**Agenda Title:** DISCUSSION REGARDING WASTEWATER TREATMENT PLANT INFLUENT METERING SYSTEM EVALUATION

**Subject: Parshall Flume Design Memorandum**

SUBJECT: Review of City of Willits Wastewater Treatment Plant Influent Flow Meter  
B&R File No. 3478.00

5 MGD As Built Condition

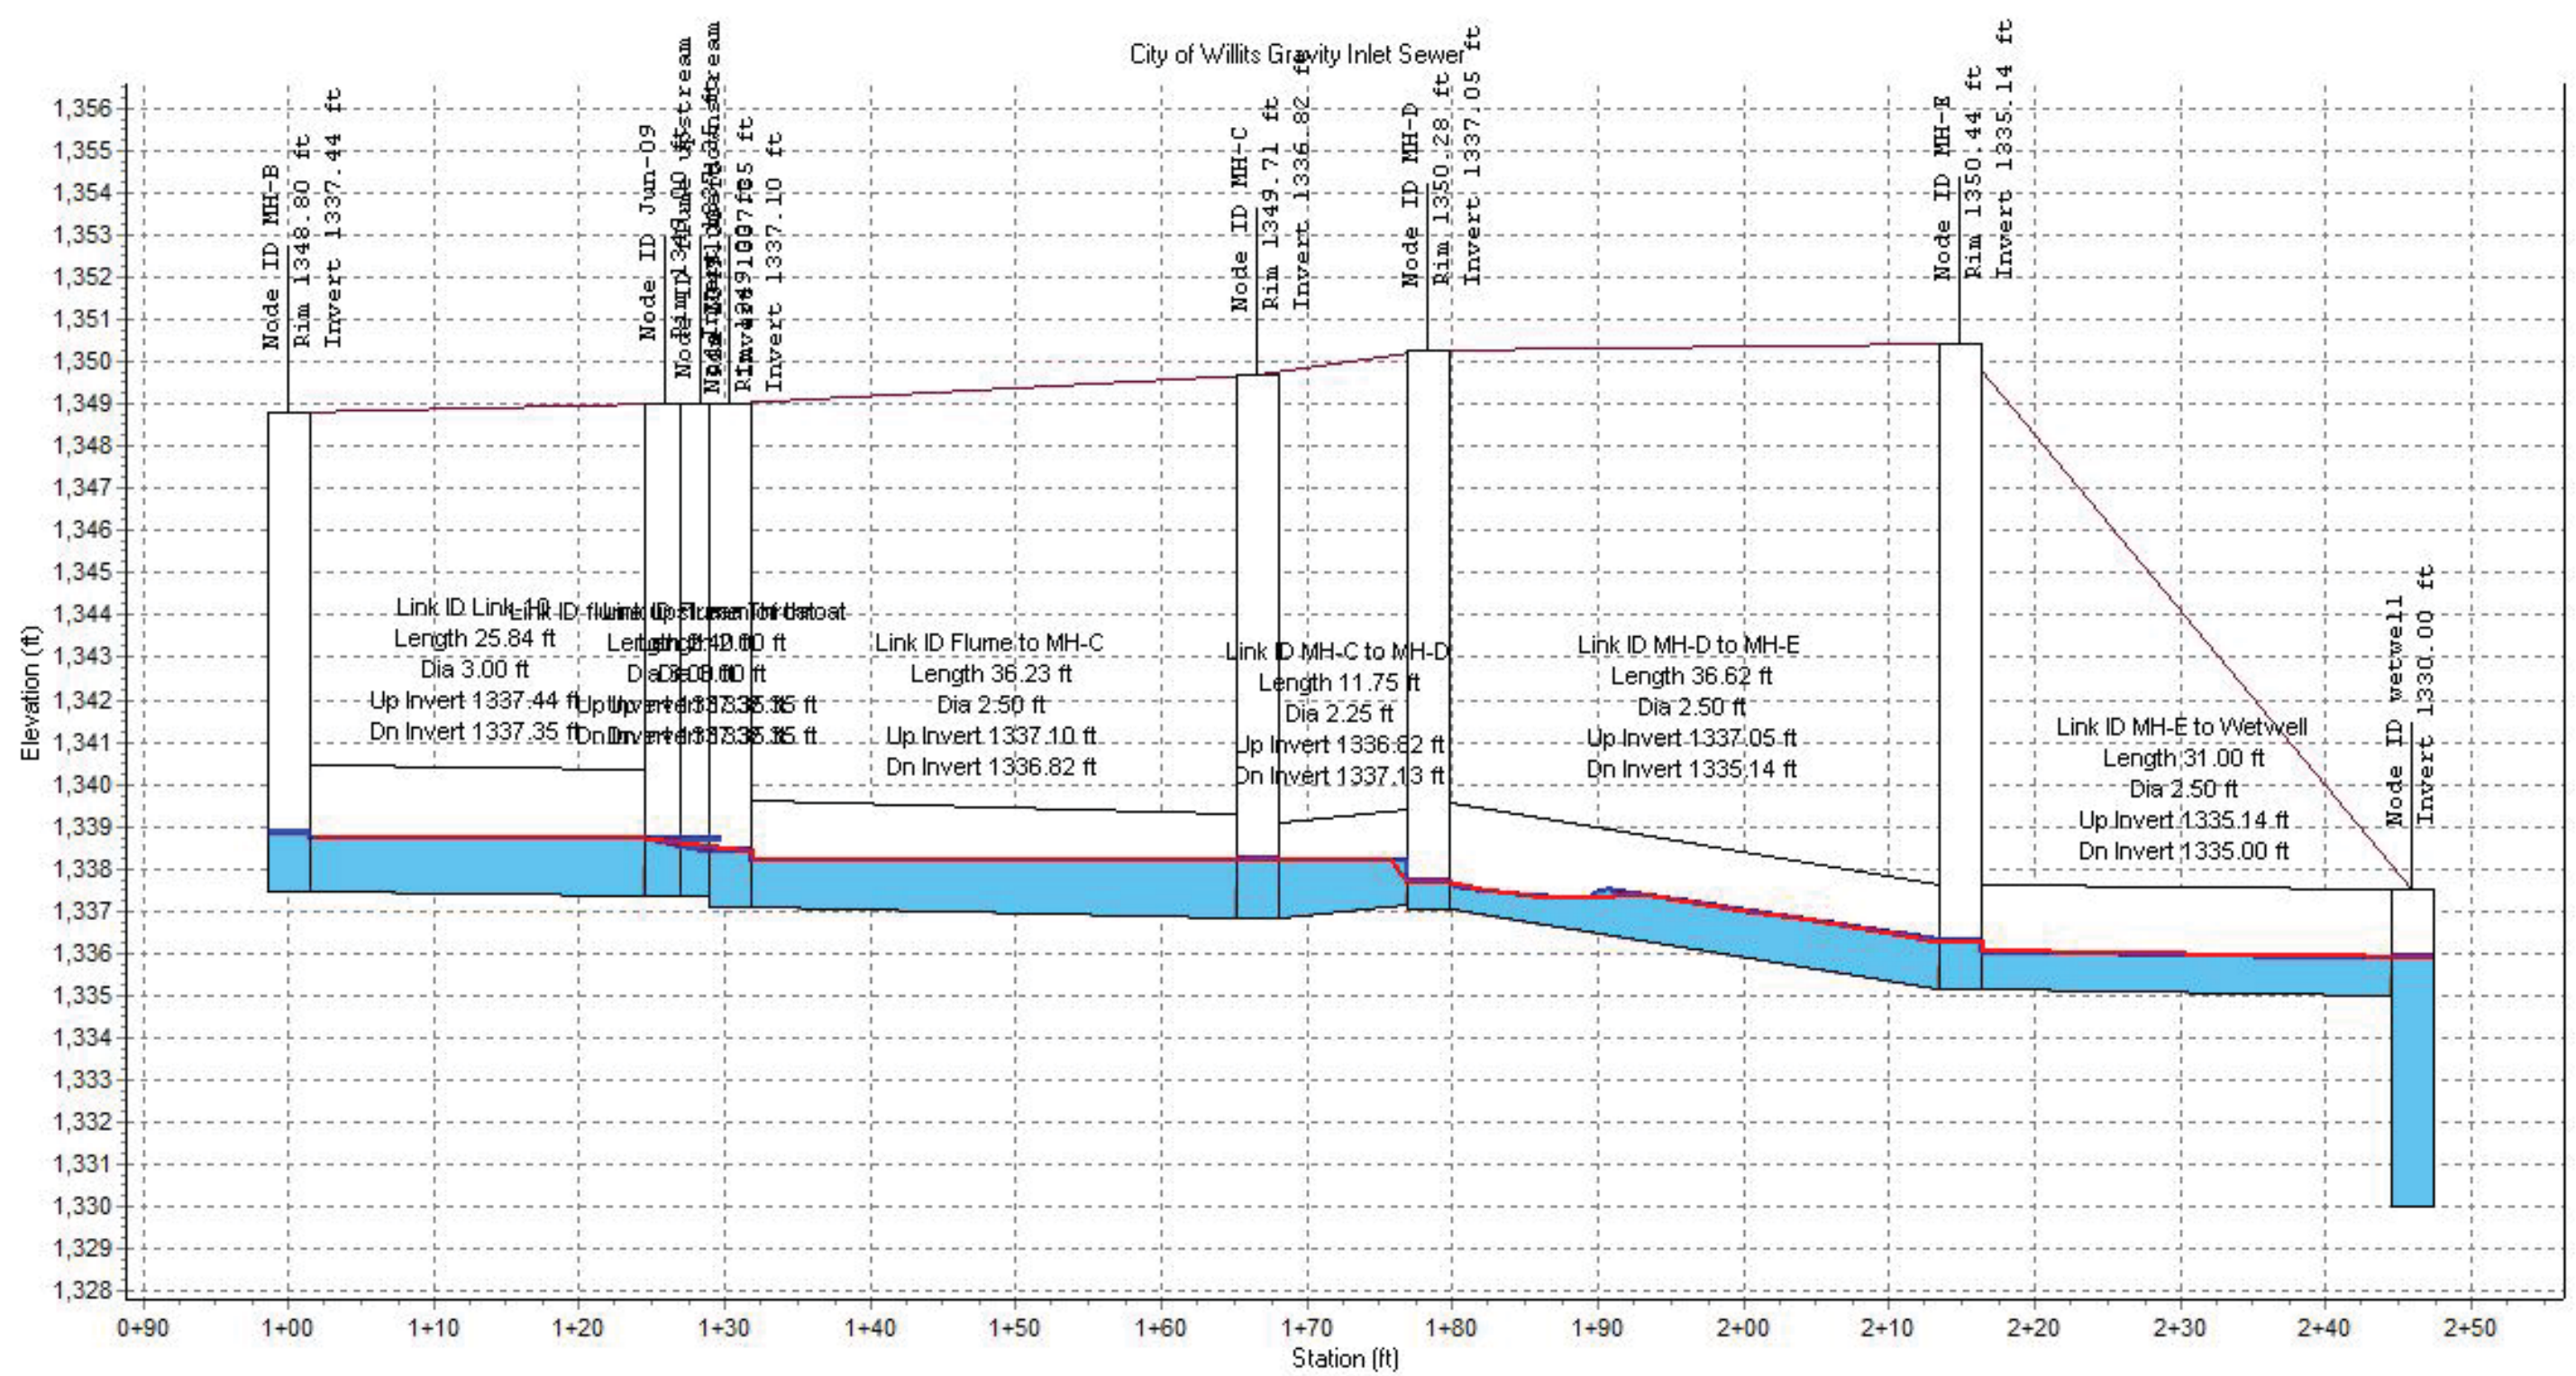
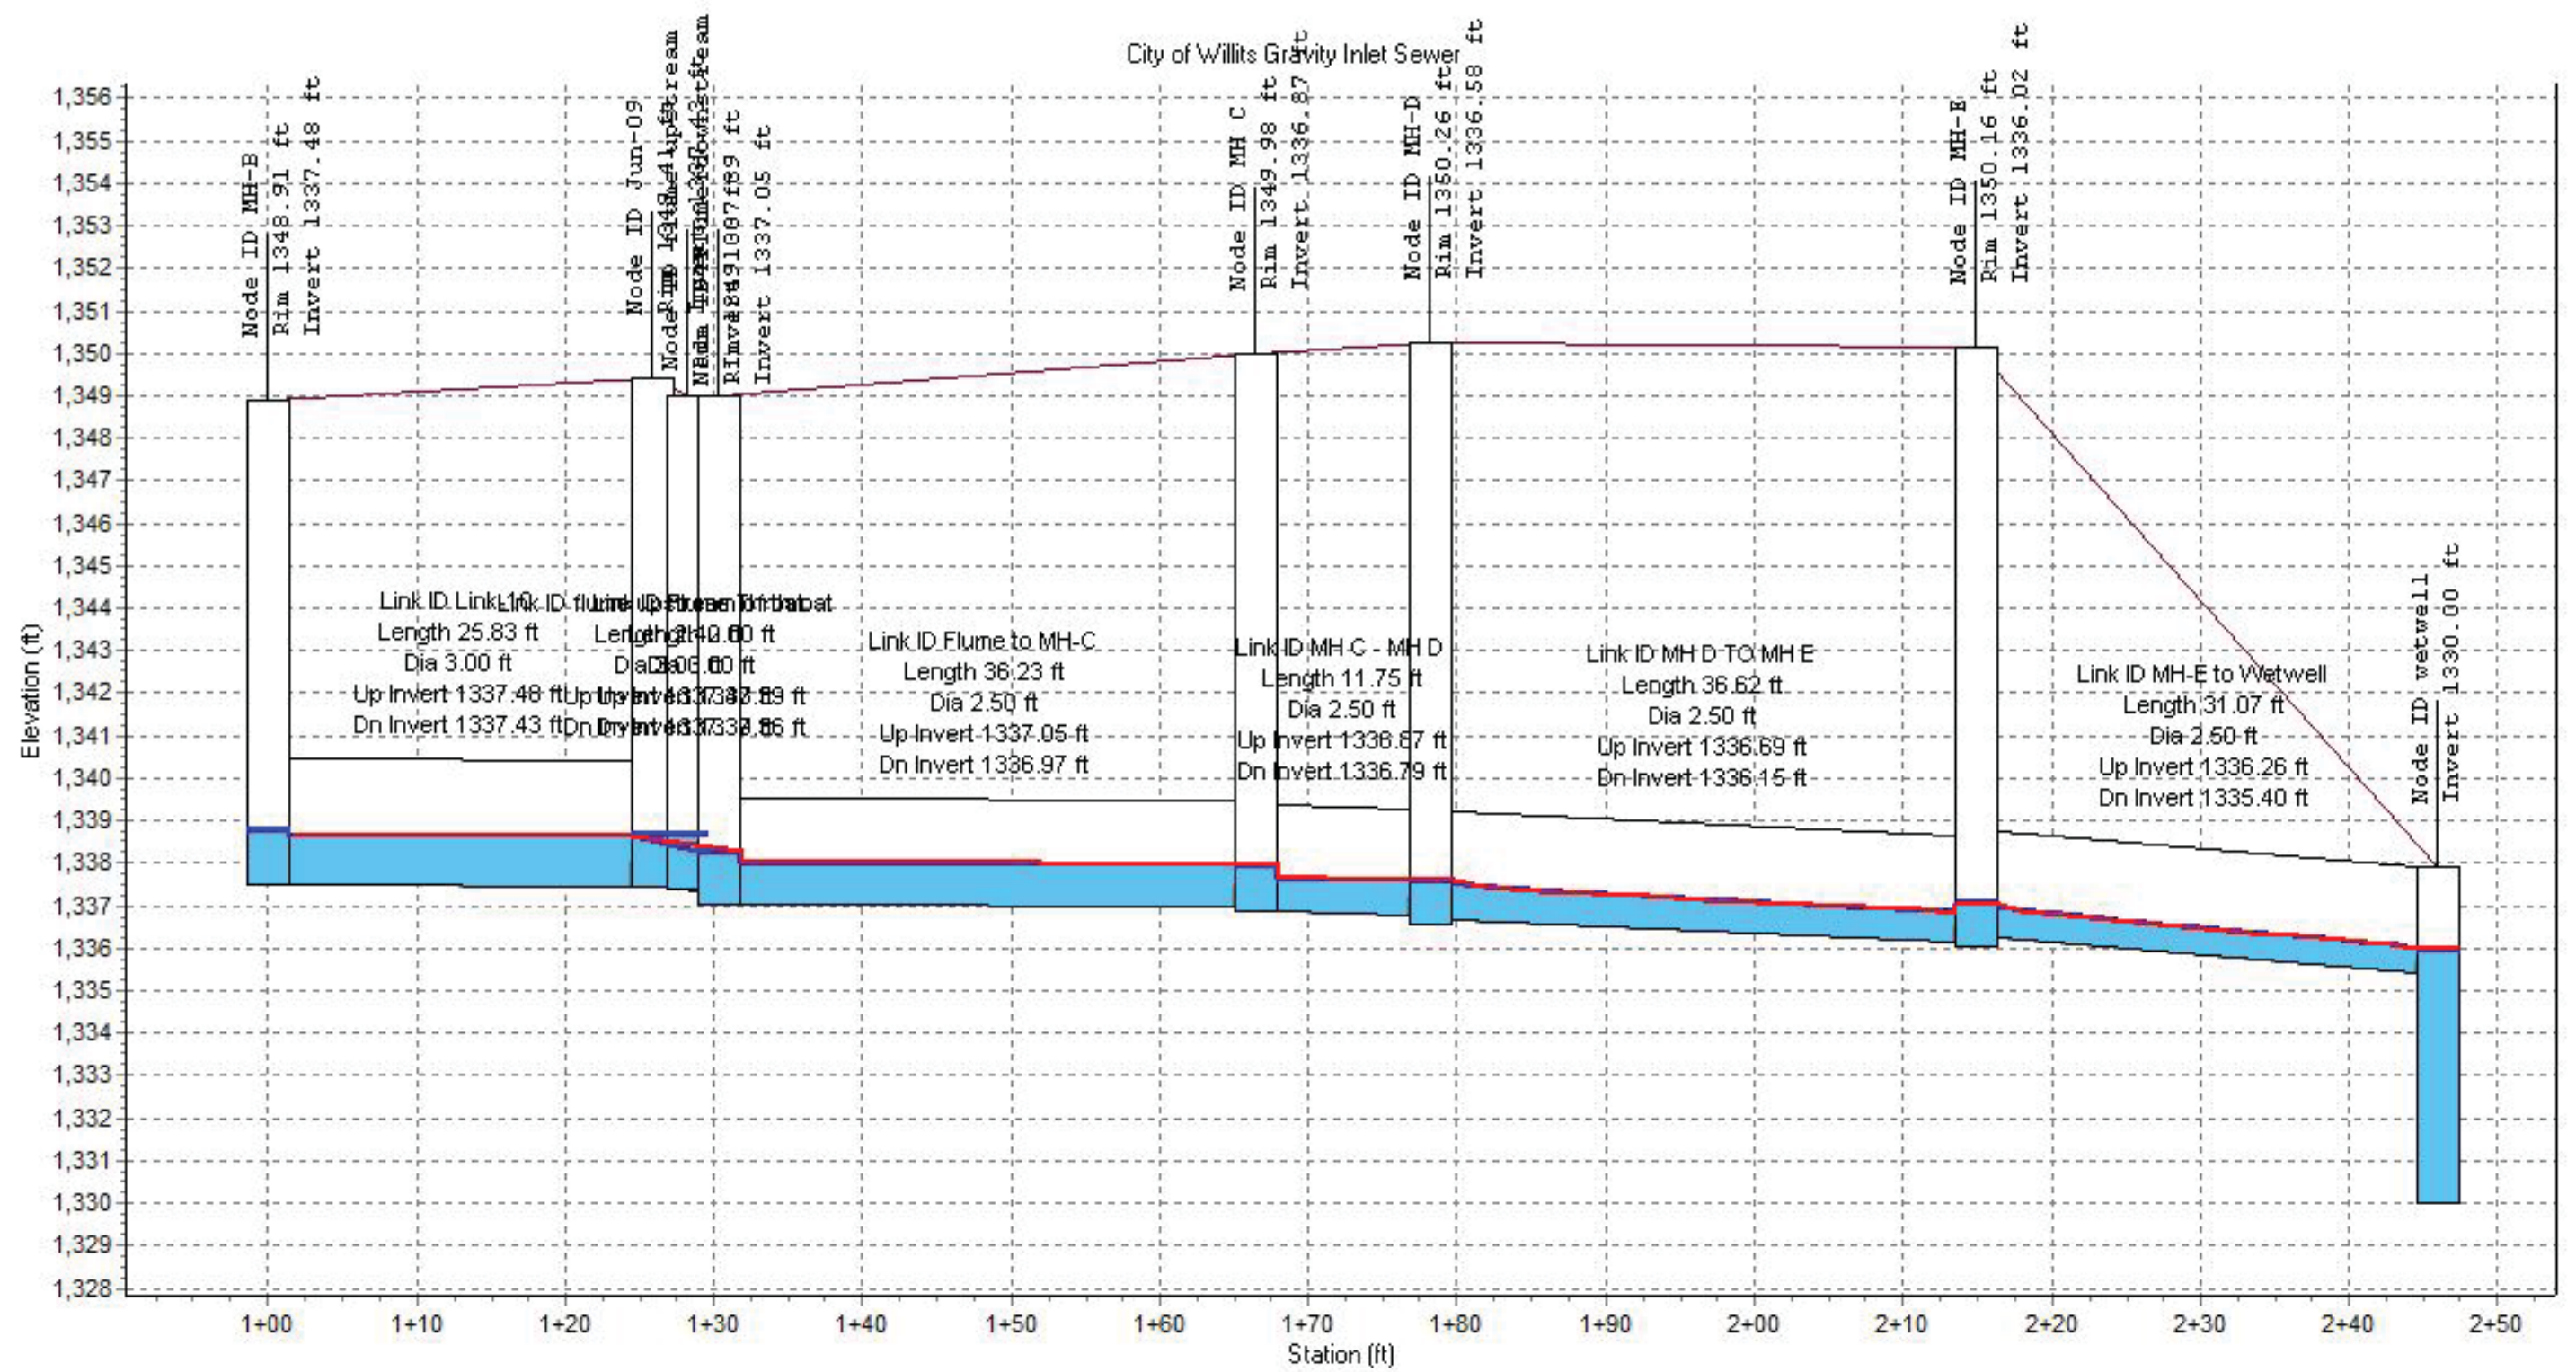
The overall model results (see attached hydraulic profiles) show that there are effects at the flume due to backwater under all three flow conditions for the as-built condition. Based on the published data, the backwater effect would result in a reading of 1.21 MGD vs. 1.18 MGD (2.5% increase), then 6.15 MGD vs. 5 MGD (23% increase), and finally 12.23 MGD vs. 10 MGD (22% increase). The model also indicates that at the as-designed condition, there would be some backwater effect at the 5-MGD and 10-MGD flow depths.

Based on discussions with a flume manufacturer, there are two ways to mitigate for the backwater effects on the flow measurement. The first is to raise the floor of the flume so that the bottom of the flume is above any backwater effects from downstream. The second is to install ultrasonic level readers at two locations along the flume. The level readings would then be fed to a programmable logic controller (PLC), which would use the correct theoretical equation, based on the presence or absence of backwater conditions, to calculate the correct flows to within the normal tolerance of a
